16 November 2022

Our Ref: P222\_139

**Redfern North Eveleigh Precinct Renewal Project - Chief Mechanical Engineer's Building  
ACCESS Capability Statement for State Significant Development Application**

1 SITE PLAN  
SCALE 1 : 150

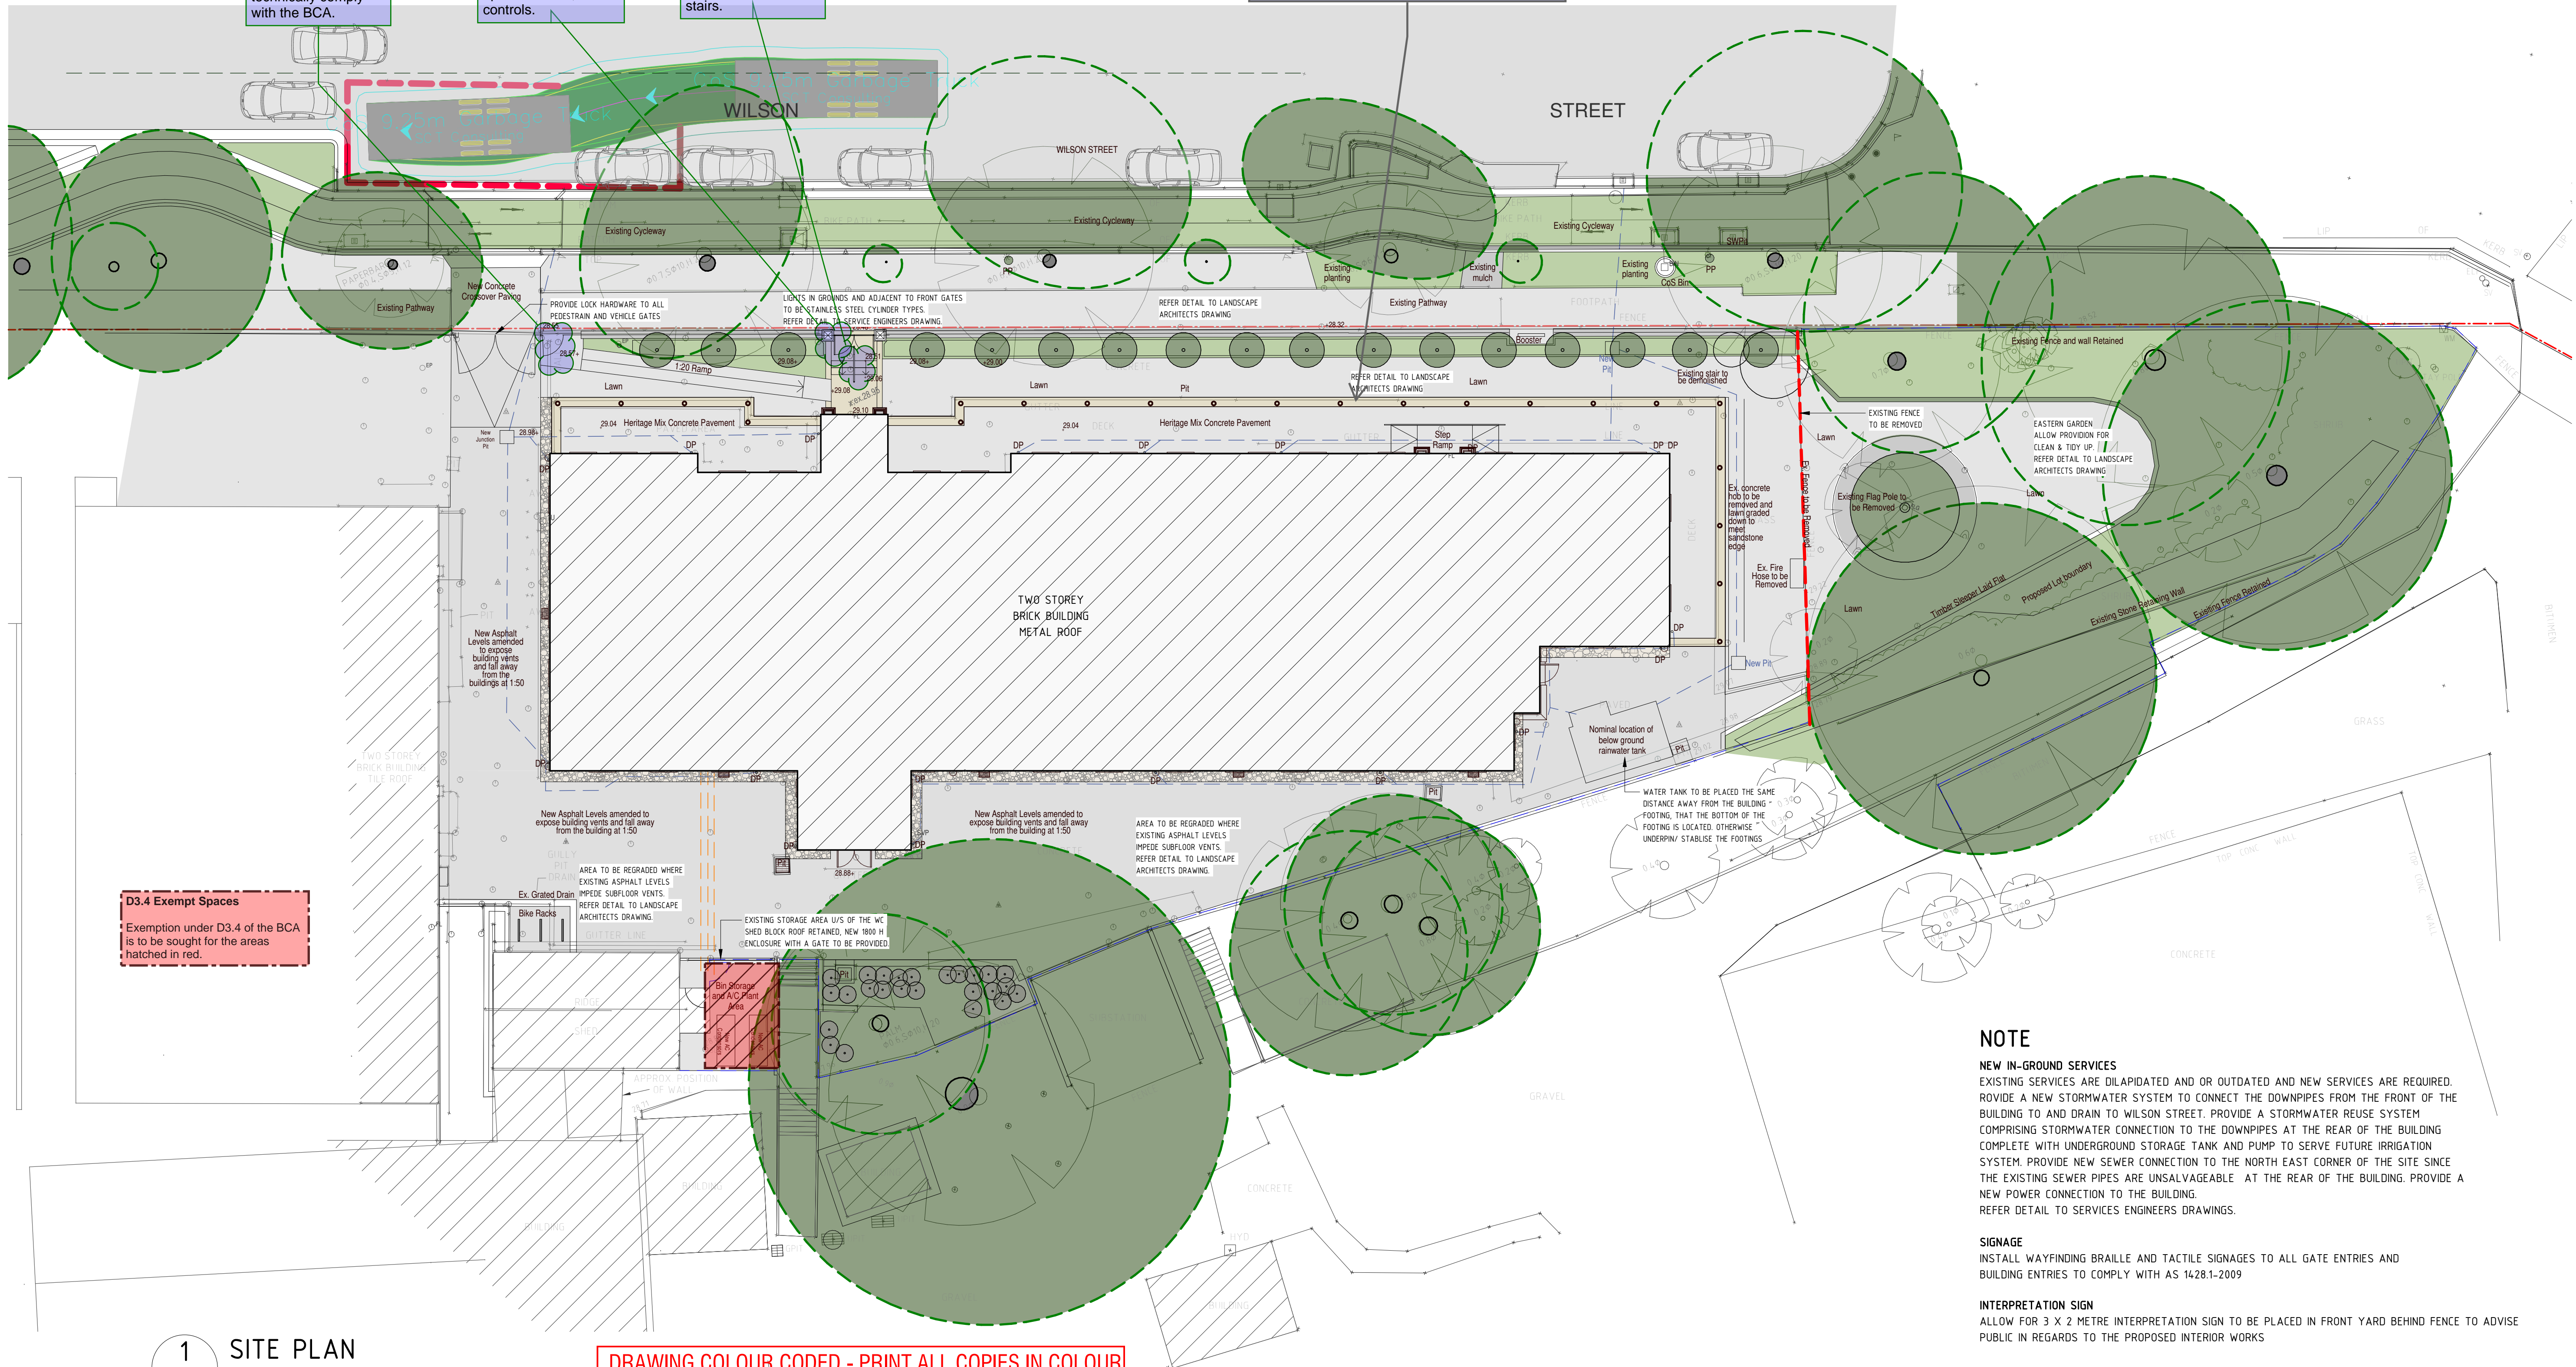
4. Performance Solution  
Gate circulation clearances to both gates to be achieved outside of the allotment boundary and therefore do not technically comply with the BCA.

4. Performance Solution  
Gates to be operated by dedicated staff given non compliances with operable force, door controls.

5. Performance Solution  
Handrail not provided either side of flight of stairs.

2. Performance Solution  
The floor or ground surface abutting the sides of the walkway shall provide a firm and level surface of a different material to that of the walkway at the same level of the walkway, follow the grade of the walkway and extend horizontally for a minimum of 600 mm.

D3.4 Exempt Spaces  
Exemption under D3.4 of the BCA is to be sought for the areas hatched in red.

**ARCHITECTURAL**  
PROPOSED GROUND FLOOR PLAN

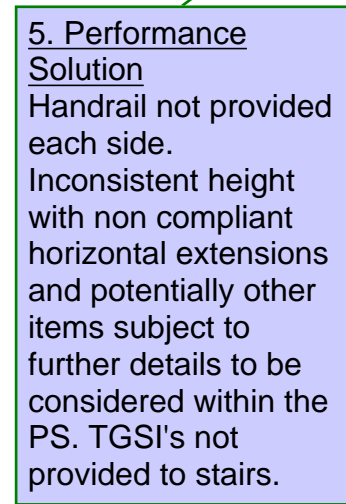
**1. Performance Solution**  
Doors along affected part leading to area of new works shown with green circle may not comply with door opening width, door controls, door clearances etc Justification would be kept the door fixed open or identify rooms where assistance will be required to approach those rooms i.e G2, G21, G4

**7. Performance Solution**  
We understand the existing Accessible WC is being relocated to Level 1. As an accessible WC is not provided with the GF bank of WC's a Performance Solution is required.

**6. Performance Solution**  
Non gender WC's where serving more than 10 staff to be addressed by a Performance Solution.

**5. Performance Solution**  
Handrail not provided each side. Inconsistent height with non compliant horizontal extensions and potentially other items subject to further details to be considered within the PS.

**3. Performance Solution**  
Change room considered a common area. Accessible shower and WC on L1 to be identified as accessible changing room.

**D3.4 Exempt Spaces**  
Exemption under D3.4 of the BCA is to be sought for the areas hatched in red.
